Microcontroller Technical Information

SM+ for 78K0R System Simulator for 78K0R Usage Restrictions	Document No.	ZBG-CD-08-0037	1/1
	Date issued	September 25, 2008	
	Issued by	Development Tool Solution Group Multipurpose Microcomputer Systems Division Microcomputer Operations Unit NEC Electronics Corporation	
Related documents SM+ System Simulator Operation: U18601EJ1V0 (1st edition) SM+ System Simulator User Open Interface: U18212EJ2V0 (2nd edition)	Notification classification	√	Usage restriction
			Upgrade
			Document modification
			Other notification

Restrictions on SM+ for 78K0R

No. 33 Restriction on Stack window

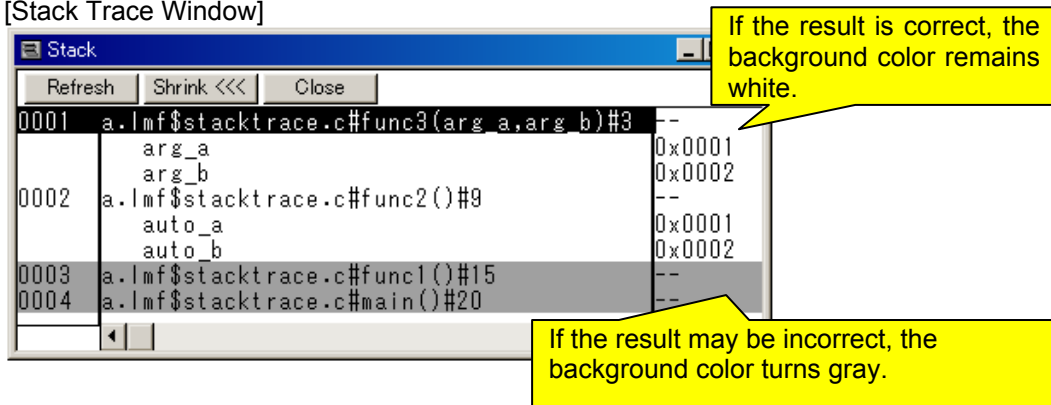
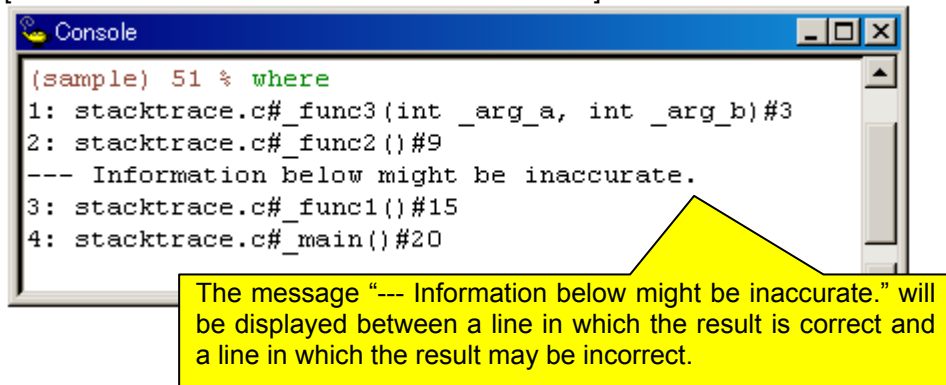
The Stack window cannot be used. (The related menus and buttons appear dimmed so this window cannot be opened.)

Whether the result of tracing by the stack trace function is correct varies depending on the state of the stack. Following this correction, the specification of the view will be changed as follows.

This issue will be corrected in the next version.

No. 34 Restriction on event links

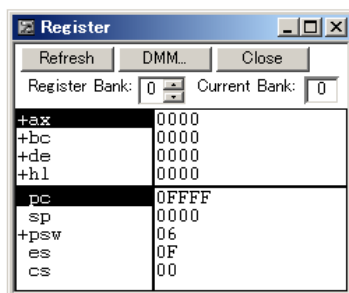
If an event is created with "Register" or "Memory" specified from the Event Status drop-down list in the Event dialog box, only Phase 1 can use this event as an event link condition. The event can be specified for Phase 2 and later, but does not operate normally.

The following error will occur if the above setting is performed in the corrected version.

This issue has been corrected in V2.21.

No. 53 Restrictions on serial array units (1)

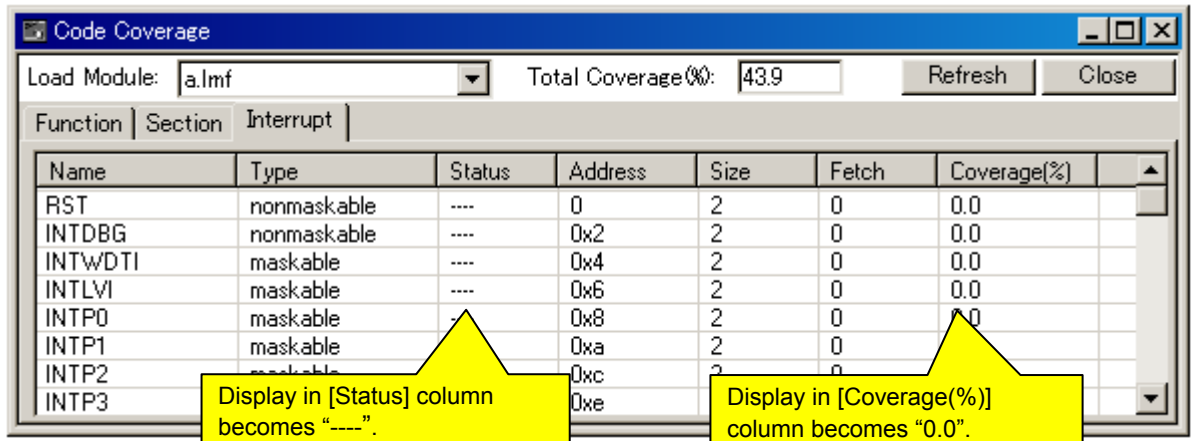
- (5) If the DAPmn and CKPmn bits of serial communication operation setting register mn (SCRmn) are set to 0,0 or 0,1 when using the CSI in the master mode, the serial clock (SCK) will be output for a period 1 bit shorter than the specified length.

Examples in the case of 8-bit data length and MSB first are shown below.

All (1) through (5) will be corrected in the next version.

No. 54 Restriction on Code Coverage window

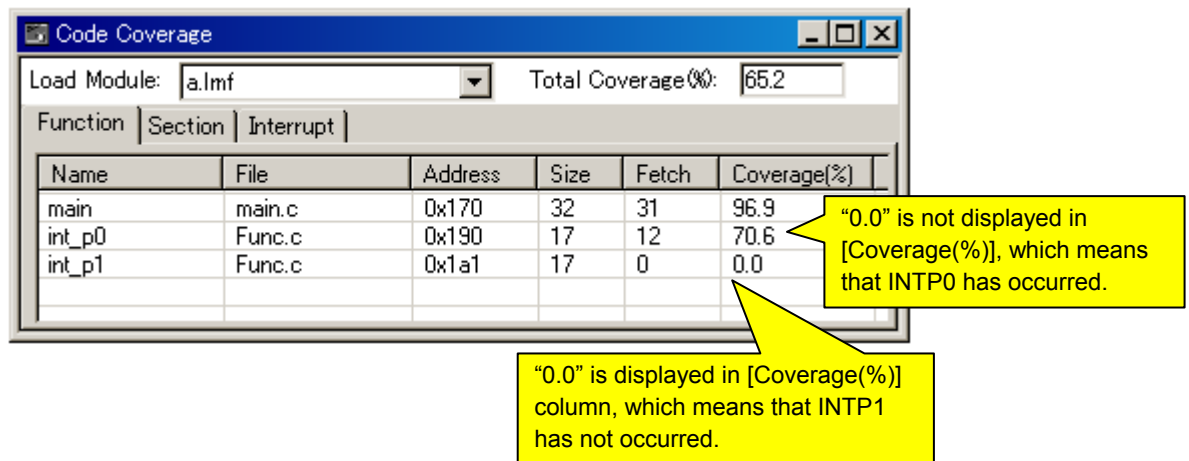
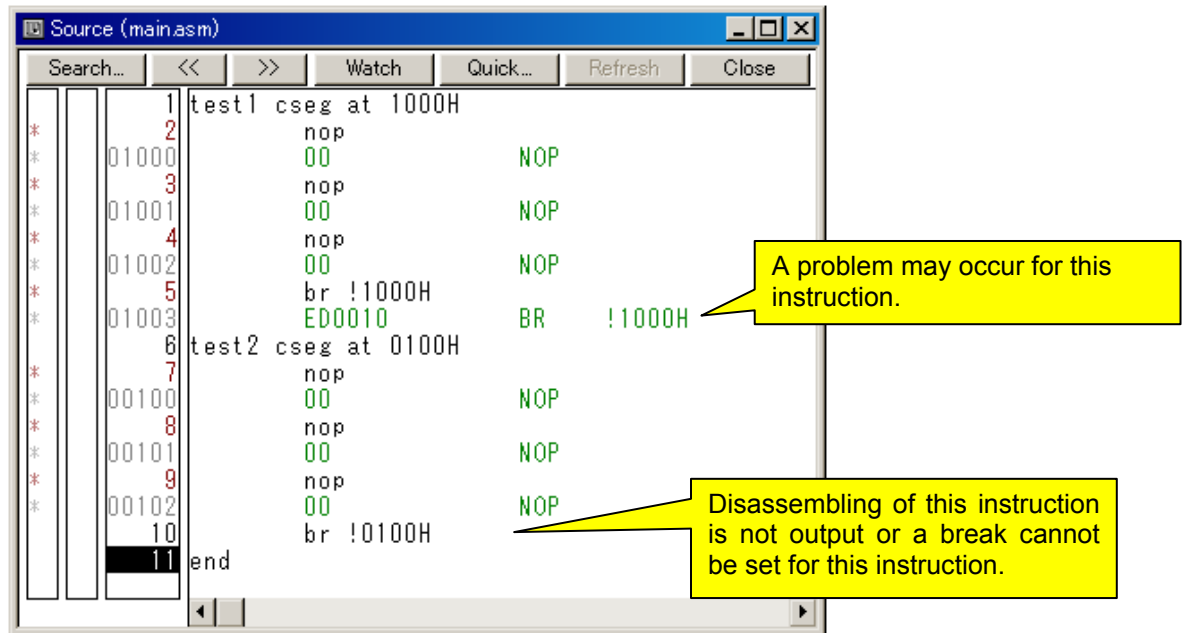
Value "0.0" is displayed in the [Coverage(%)] column on the [Interrupt] tab in the Code Coverage window, regardless of the occurrence of interrupts. In addition, "----" is displayed in the [Status] column on the [Interrupt] tab, regardless of the use of interrupt functions.

Example When interrupt INTP0 is defined as function "int_p0" and INTP1 as function "int_p1"

This issue will be corrected in the next version. The operation after correction will be as follows.

- In [Status] column: "Use" is displayed when the interrupt function is defined, and "nonuse" is displayed when the interrupt function is not defined.
- In [Coverage(%)] column: "100.0" is displayed when an interrupt has occurred, or "0.0" is displayed when interrupts have not occurred.
